PAPER NUMBER: LTR-11-0592

SUBJECT: Thermal hydraulic phenomena

CALCULATION OF HYDROGEN AND OXYGEN UPTAKE IN FUEL ROD CLADDING DURING SEVERE ACCIDENTS USING THE INTEGRAL DIFFUSION METHOD

FINAL DESIGN REPORT

17. Comparison of calculated and measured cladding temperatures for NRU FLHT-5 test at 2.2 m.

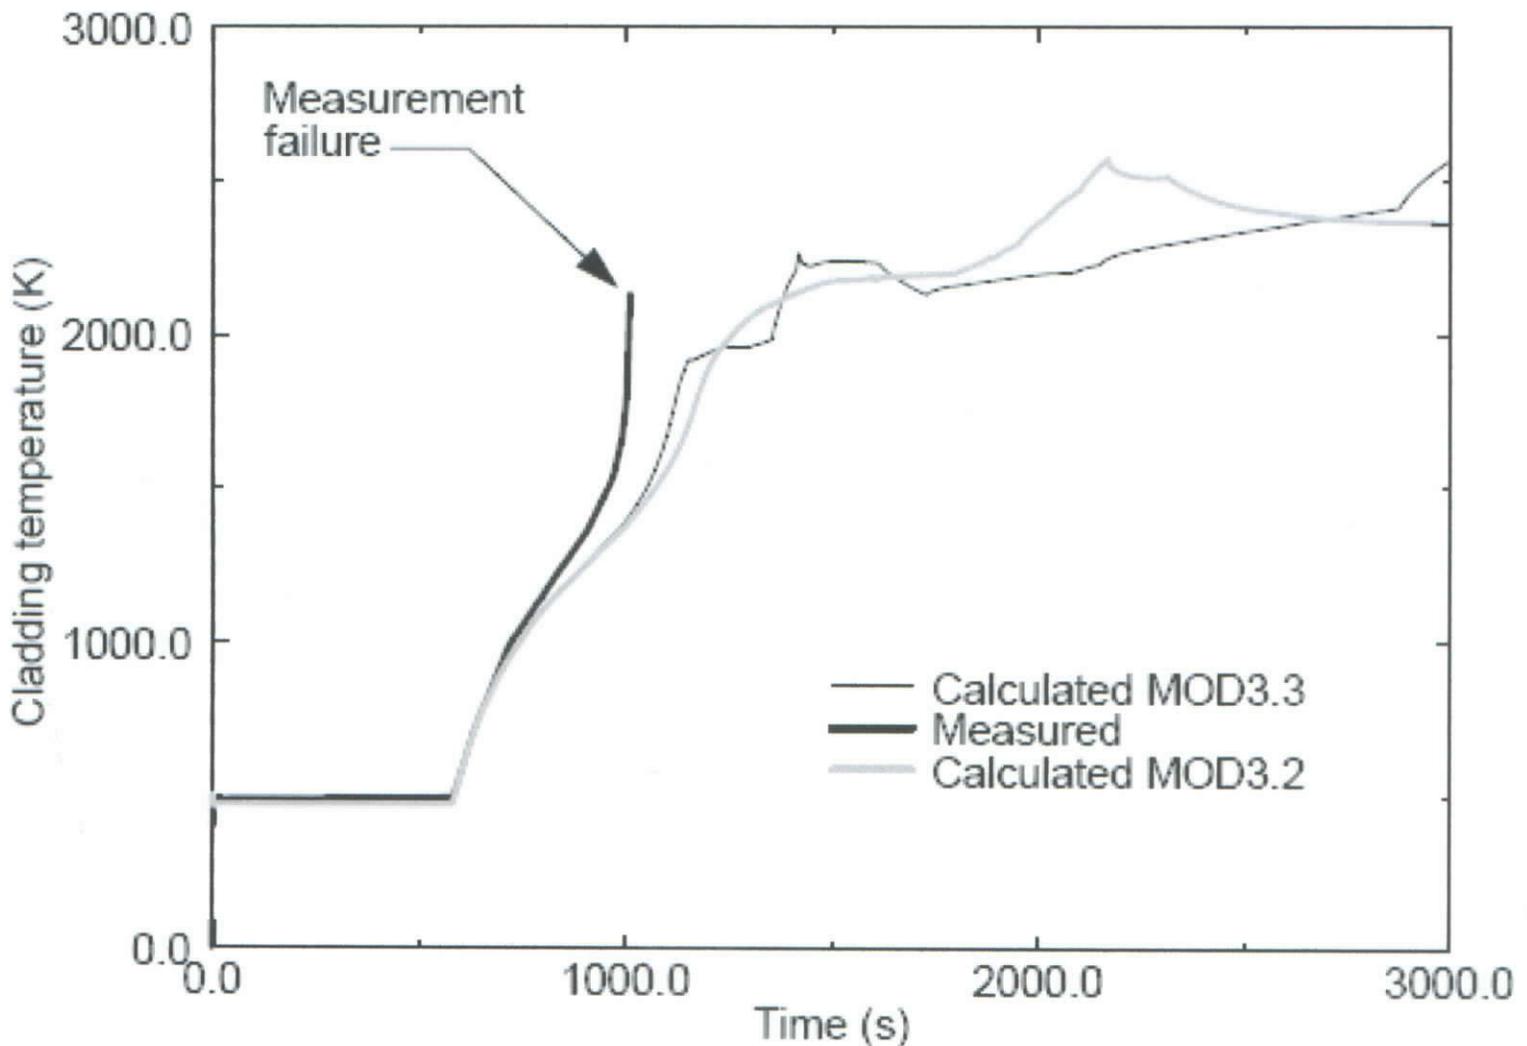
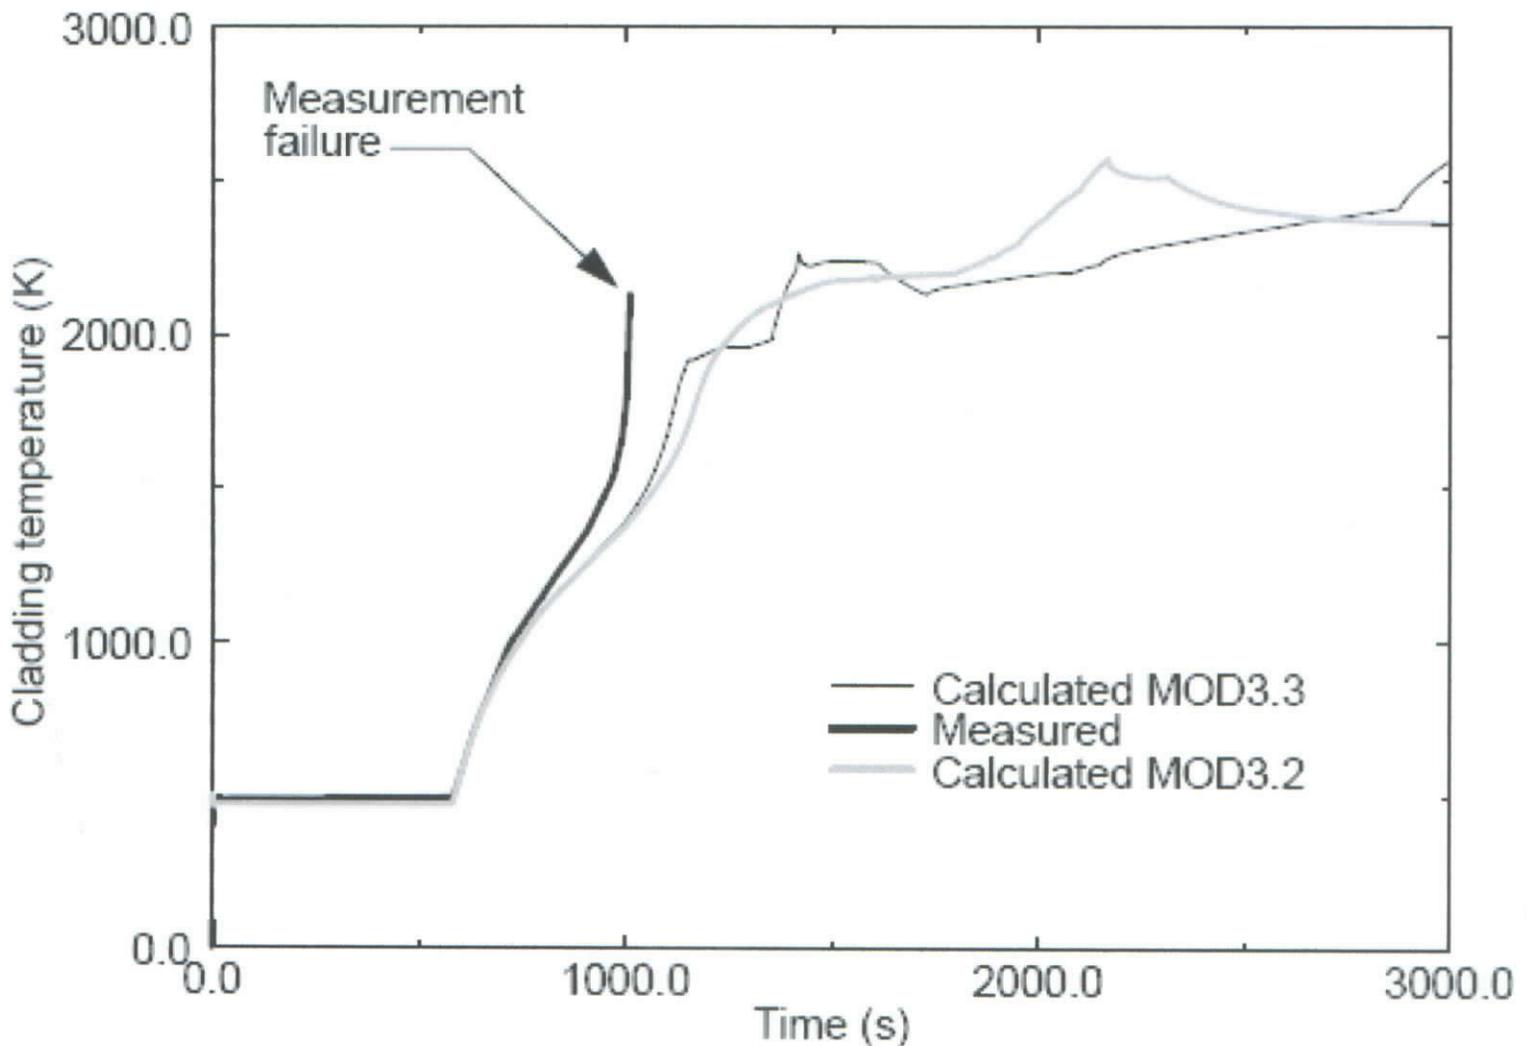
Note that in the region of 1000 K and beyond, the calculated rate of increase of the cladding temperature becomes progressively less than the measured increase. That is because the calculations are based on correlations for the characteristic of the zircaloy steam reaction that are not applicable to the NRU FLHT-5 test. The NRU test was with a multirod assembly. The correlation that was used in the calculations is based on single rod tests. The NRC has not recognized that investigations that involve heating of single specimens of zirconium alloys in steam do not yield applicable data for the temperature or range of temperatures at which thermal runaway is initiated in LWRs.
